30 July 2026

The Assessment Manager
Brisbane City Council
GPO Box 1434
Brisbane QLD 4001

Response to Further Advice Letter – Minor Change at 52–58 Queen Street and 217–235A George Street, Brisbane City (Council Ref: A007032839)

Figure 1: Food and Drink Outlet Areas

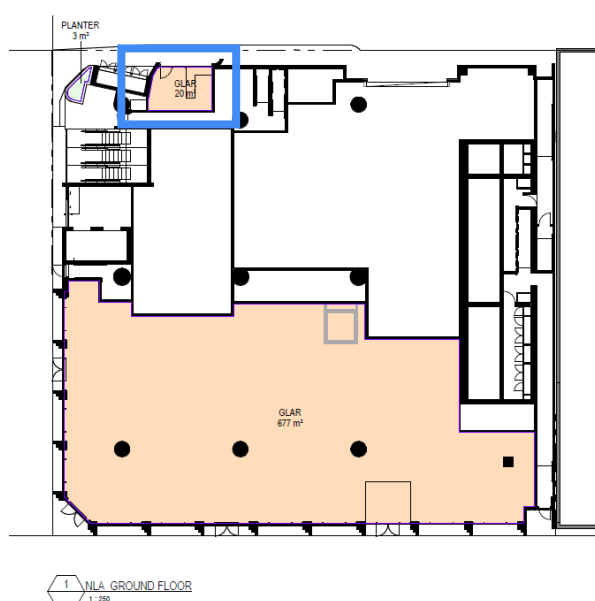
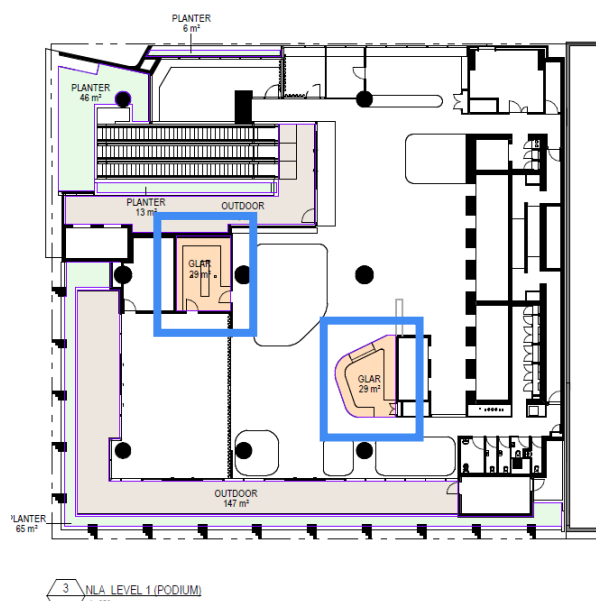
3. The Gross Floor Area (GFA) of retail and Food and drink outlet tenancies is not shown on the proposed plans as it was on the approved plans.

a. Provide amended floor plans labelling the GFA of all proposed tenancies.

The proposed design includes three Food and Drink Outlet areas that are small kiosk style operations. These total 78m² in size, which aligns with the generation rates shown in Table 1-1 of **Attachment A**. These are highlighted in blue in **Figure 1** below.

Figure 3: Updated Side Elevation

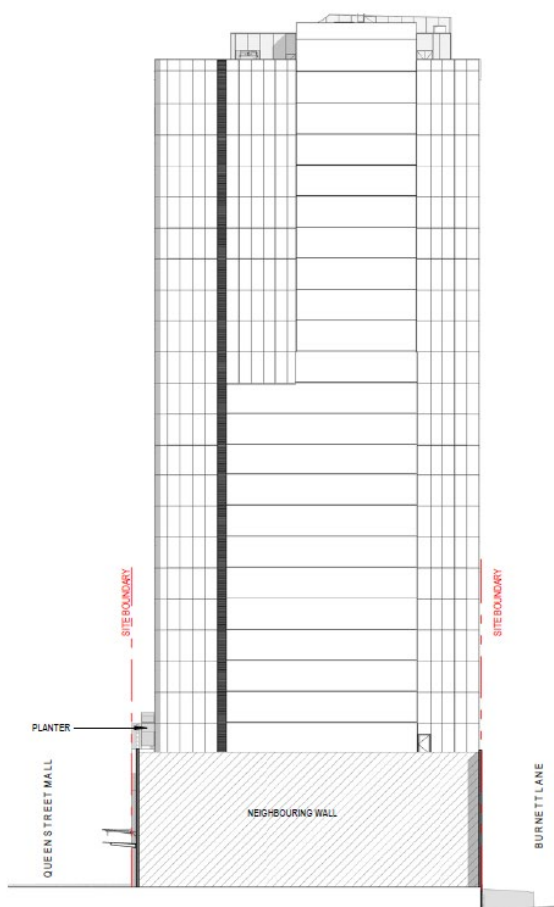
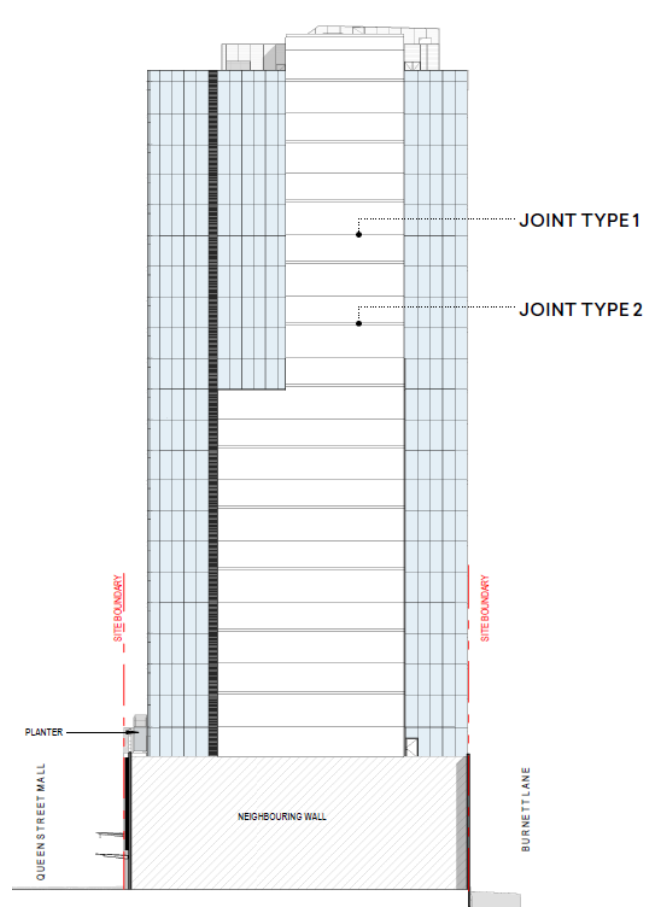
5. *There is concern that the proposed change has taken away the variation in the façade finish to the expansive concrete panelised side boundary wall that will be very visible from numerous aspects within the mall. Further variation in the plane or finish of the wall is required to reduce the visual amenity impacts.*
 - a. *Provide variation in the material, form, texture and colour of the side elevation of the tower to reduce building bulk and provide for suitable visual amenity to the cityscape.*

It is acknowledged that the proposed development is in a visible location within the City. However, any façade design must also be practical and feasible to construct. The project team explored the potential for elaborate patterning on the side wall however this was unable to be implemented due to challenges associated with certification of waterproofing treatments that would be required for the wall.

In balancing these competing needs, further expression has been integrated into the side wall through introduction of variation in the panel join profiles used for this elevation. The amended design now includes every second horizontal seam between panels featuring a wider joint detail measuring (approximately

300mm x 30mm). This arrangement is shown below in **Figure 3** with the effect illustrated in **Figure 4**. This provides the desired variation in material and texture, achieving suitable visual amenity to the cityscape.

Figure 6: Podium Presentation

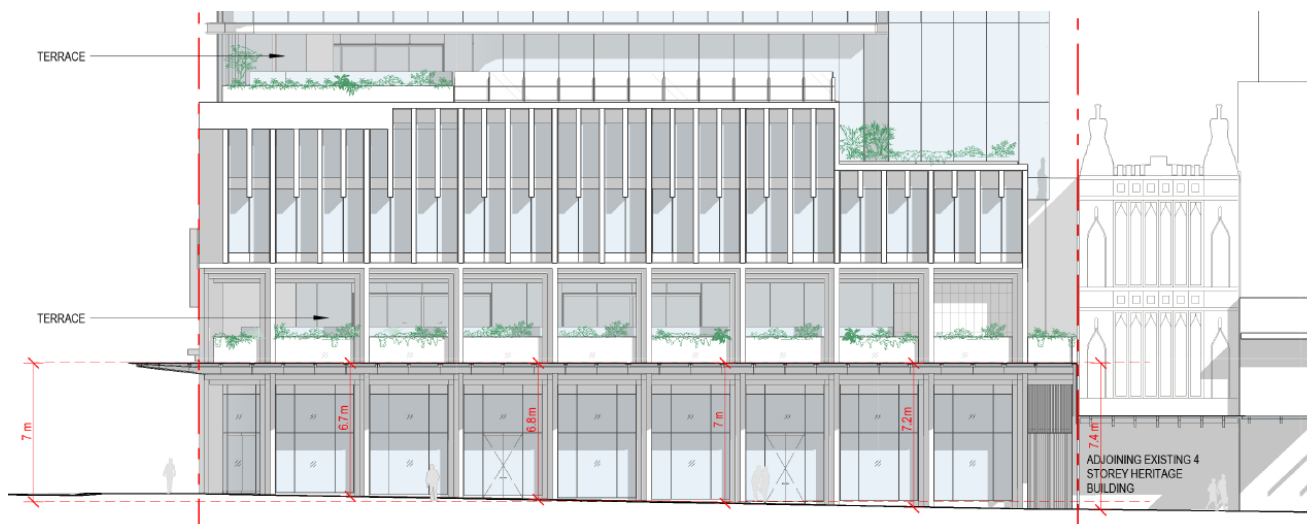
6. *The proposed changes to the podium fronting the Queen Street Mall results in the loss of sensitive built form articulation and scale that was informed by the distinctive datum of the adjoining heritage place. The raising of the awning and scale of the podium height impacts the cultural heritage significance of the adjoining heritage building.*
 - a. *Provide amended plans with design changes to provide a sensitive built form interface with the adjoining heritage place.*
 - b. *Submit a revised Heritage Impact Assessment*
 - c. *Provide additional 3D imagery.*

The height of the awning, particularly along the Queen Street frontage, is part of a deliberate strategy to provide a grand entrance to the ground floor retail entrances. **Figure 6** below illustrates this strategy and the general presentation of the development from the Queen Street Mall level.
